NOTICE UNDER SECTION 96 (1) CHAPTER IX OF THE BOMBAY
DISTRICT MUNICIPAL ACT 1901 AS MODIFIED
UP TO THE 1st MARCH 1913.

PLAN
SHOWING PROPOSED FIRST FLOOR
ON PLOT NO 114 SHEET J.M.1
JAMSHED-QUARTER
SCALE 8'-1"

Case No. P/C 92 of 1932

REFERENCE No. B S P. 92 OF 193

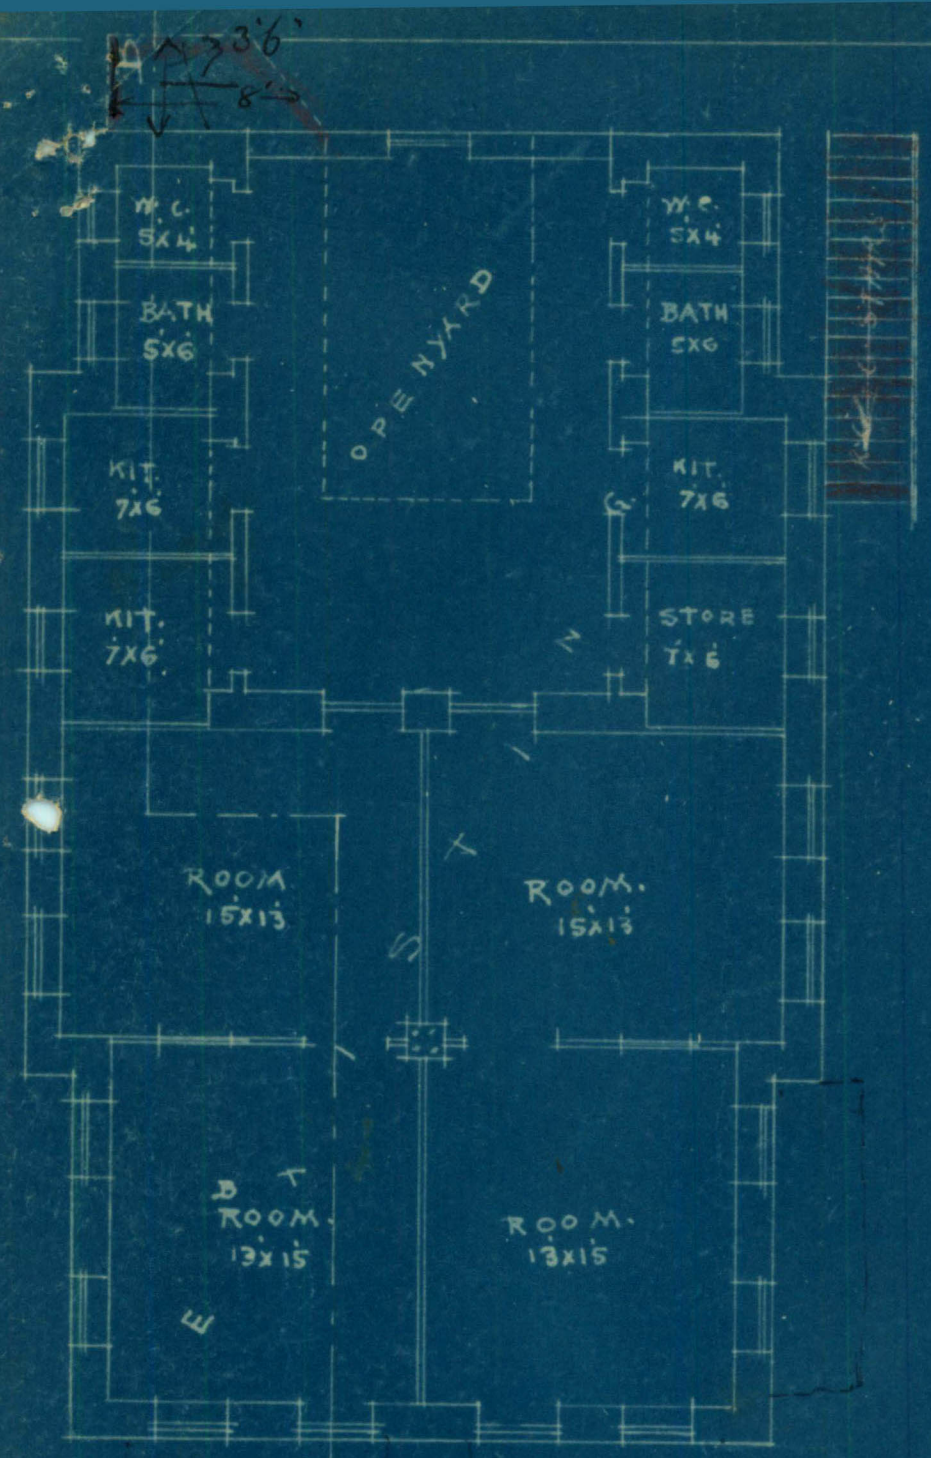
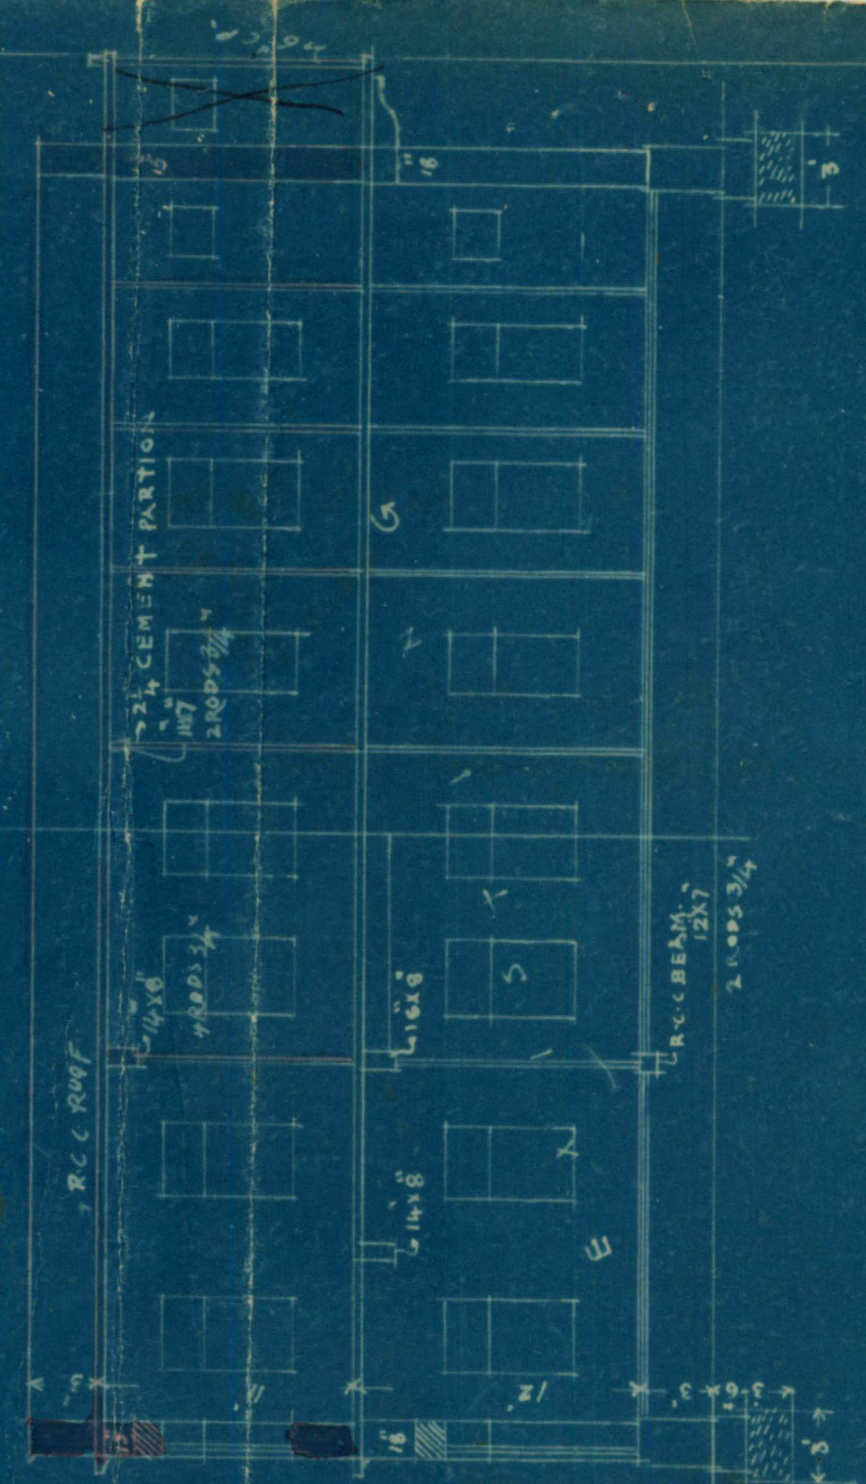
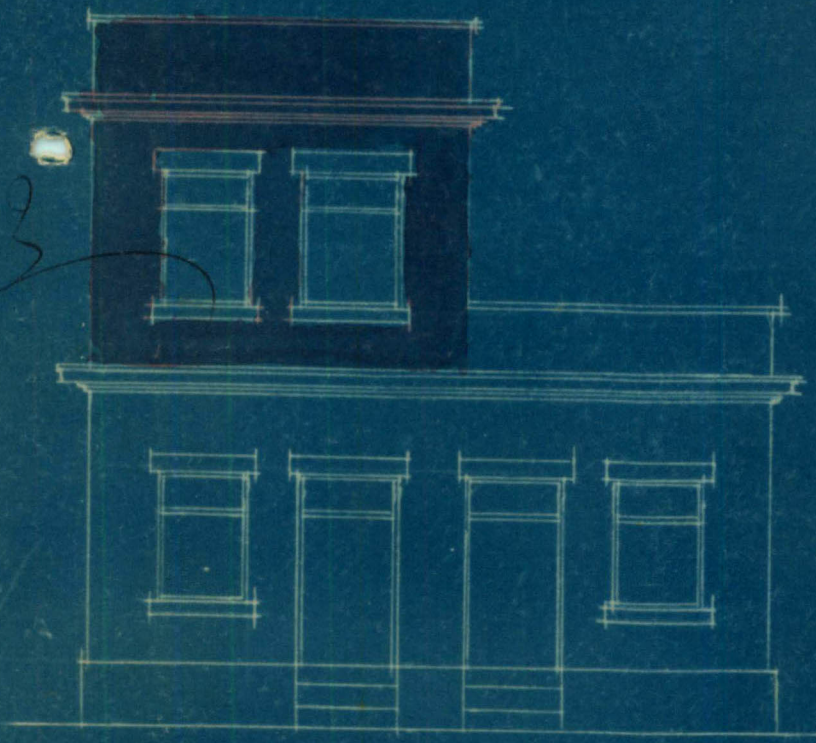
1. Balconies existing in the building must be shown in the plans and their dimensions given
2. Staircases shown in the plans or drawings are not seen at site they must be deleted
3. L.C. on a balcony cannot be allowed
4. Owner's signature must be translated into English Characters.

- (1) Balconies existing in the building must be shown in the plan and their dimensions given.
- (2) Staircases shown in the plan as existing are not seen at site. They must be deleted.
- (3) W.C. on a balcony cannot be allowed.
- (4) Owner's signature must be translated into English characters.
- (5)
- (6)
- (7)
- (8)
- (9)

- (1) It is not understood why spiral staircase
is proposed within 10' open space from road.
This cannot be allowed.
- (2) 6' cement wall for balcony cannot be allowed
Open railing 4'- high must be proposed.

*Objection complied with
except No: 3 of W.C. on a
balcony cannot be allowed.
Re: objection No: 3, the gallery
is counted in area & hence
there is no objection to
its being allowed.
7/3/33 Wm. Fiddam*

*We can't be allowed
the W.C. is quite
beyond the Bengal.
Yours faithfully,
7/3/33
Land Manager & Architect*

With reference to your letter No. B.G.P. 92/33 dated the 26 th. April 1933, we have the honour to state that it is proposed to keep the *spiral* stairs and the gallery beyond 10ft. from the road. It is shown in the site plan like this.

Submitted to the B.G.P. for the gallery at room a 6' c.p. is proposed 6' high as the material goes at right to provide ventilation and light. This requirement complied with 18/5

Both same to the Council as building up and of the balcony is for to call same 6' P.W. all as Screen Wall P.S. run
Submitted
Building is taken as built up area 18/5
